COMMUNITY BOARD FEEDBACK PACKAGE

DINING OUT NYC COMMUNITY BOARD RECOMMENDATION FORM

Business Name: Da Andrea Ristorante
Cafe Setup Address: 160 8th Avenue, New York, NY, 10011
Application Number: 20240404010002
Recommendation Response Deadline: 6/22/2024
NYCDOT Internal Use Only

**PLOT PLAN,
SIDEWALK & ROADWAY
CAFE PLAN**

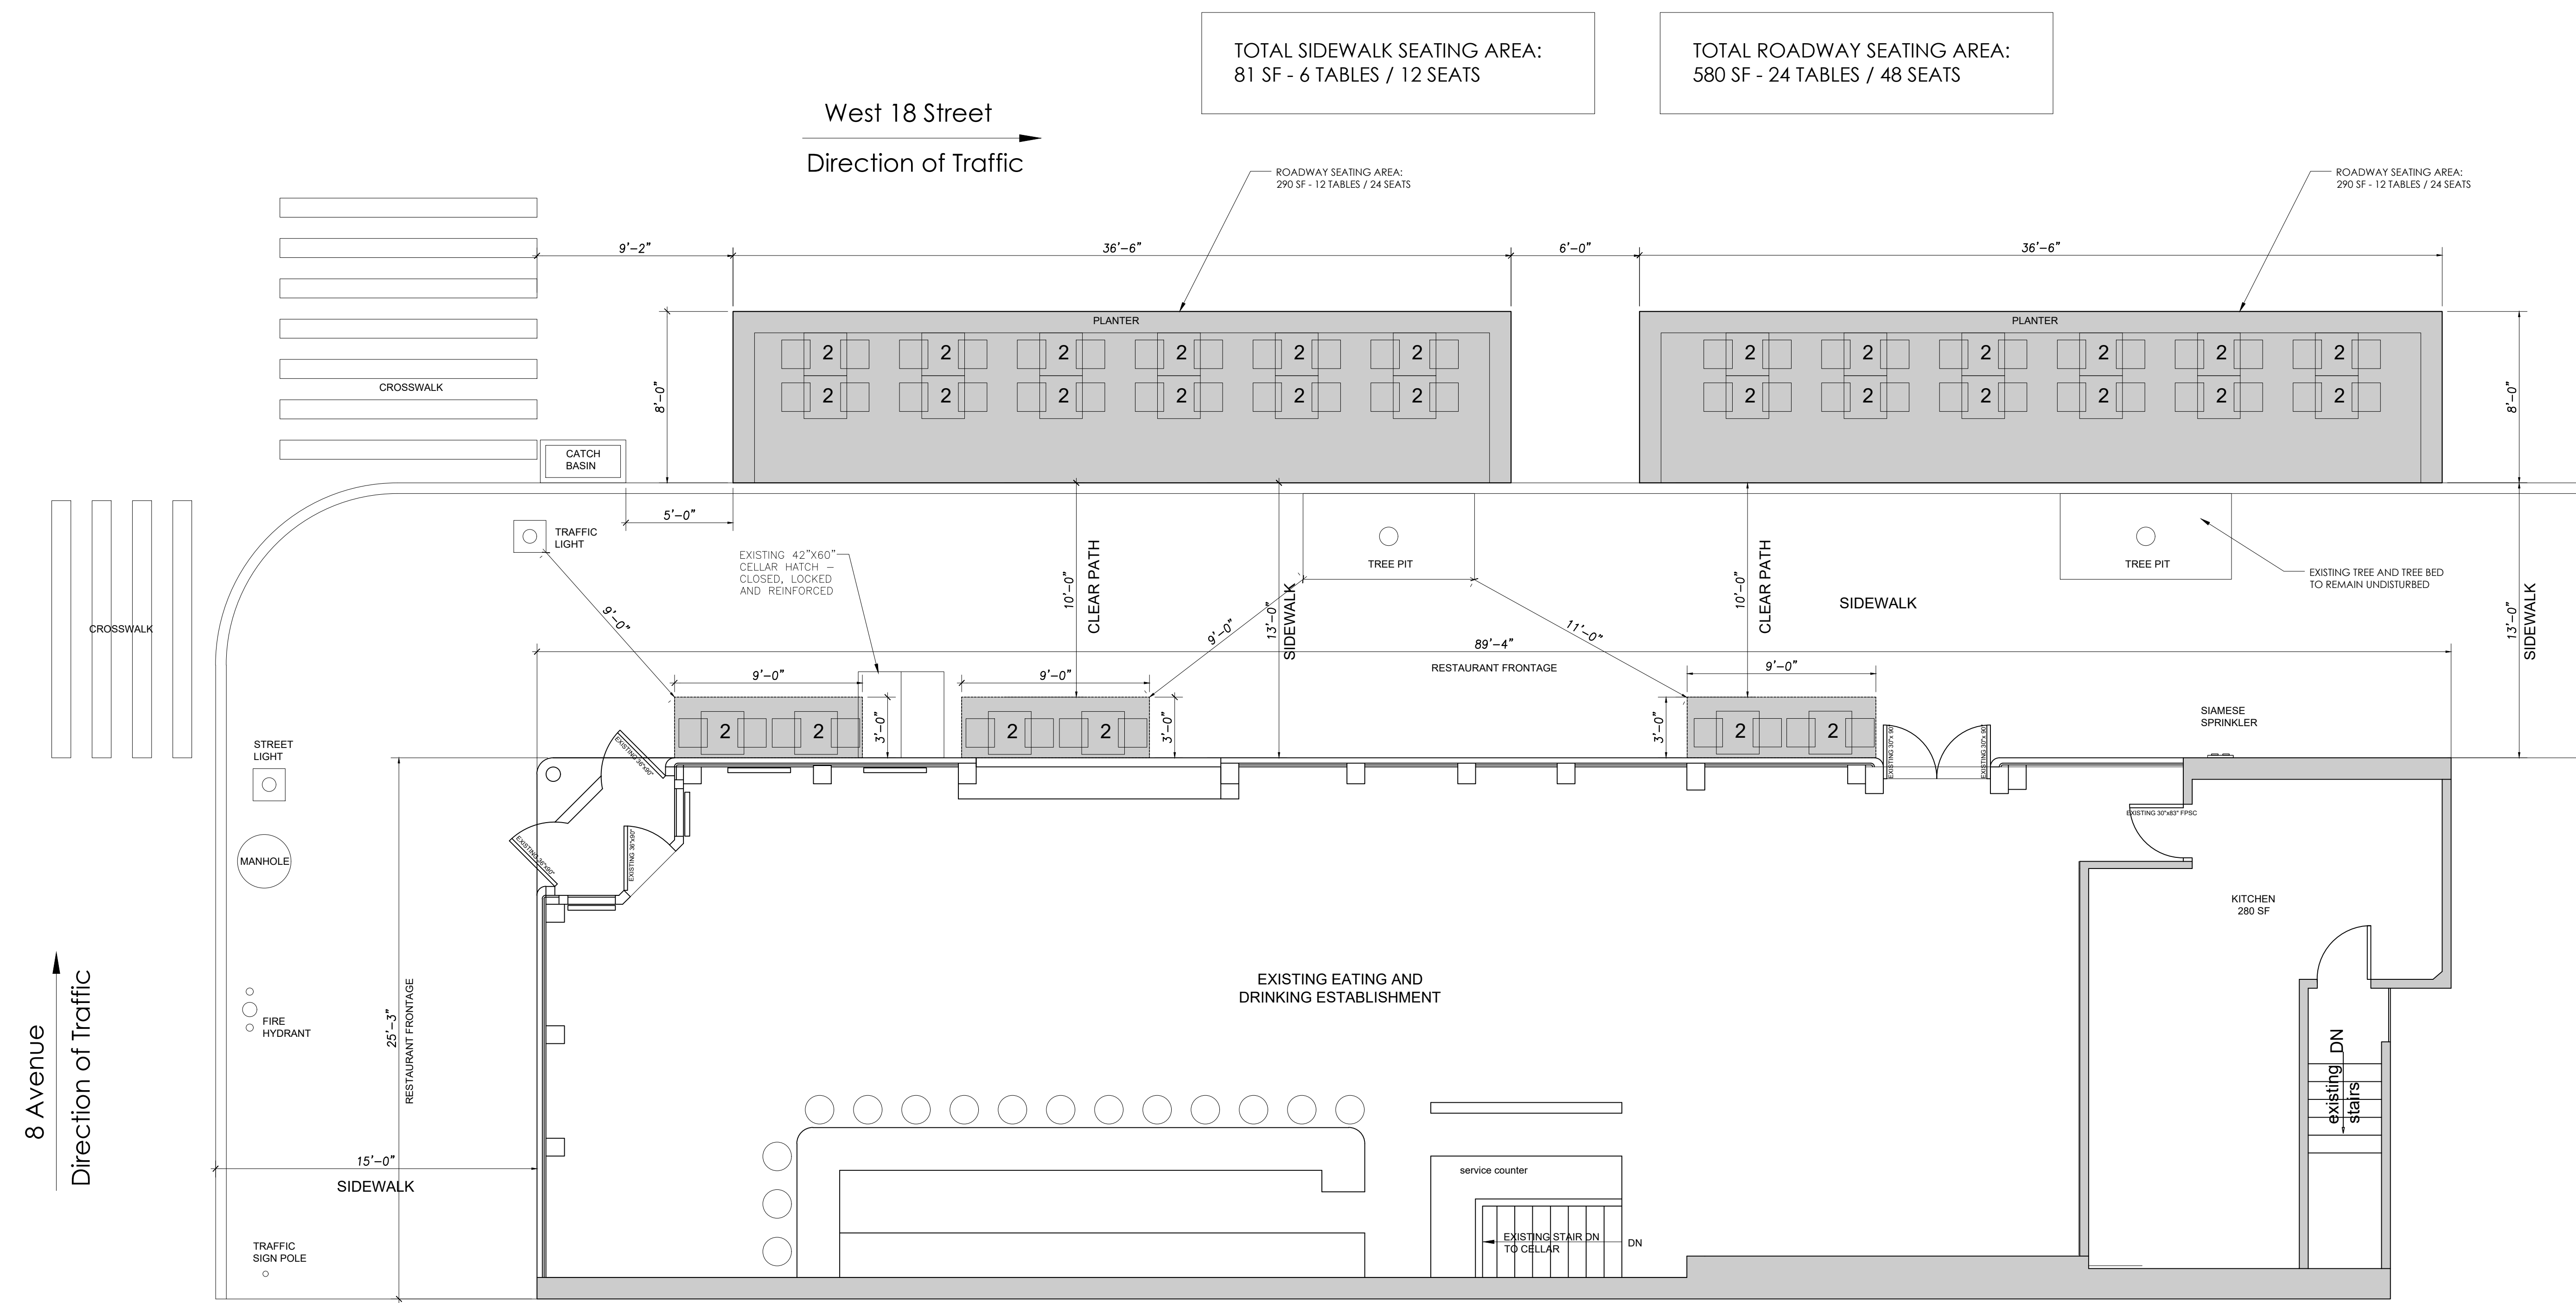
8th Avenue cafe does not provide sufficient space to comply with the rule "employees serve patrons solely from within the perimeters of such sidewalk cafe". Adding a minimum of 2ft to the cafe to allow service would make the clear path between the cafe perimeter and the fire hydrant directly in front of the cafe less than the required 10ft. One table from the 18th Street cafe must be removed because, after adding a minimum of 2ft to the cafe to allow service, the clear path between the cafe perimeter and the tree pit is less than the required 8ft.

One table from 18th Street cafe should be removed -- third table starting from the east going west, as marked on accompanying floor plan.

Cafe shall be closed and vacated of patrons no later than 11pm Friday & Saturday and 10pm Sunday-Thursday. There will be no cafe on 8th Avenue.
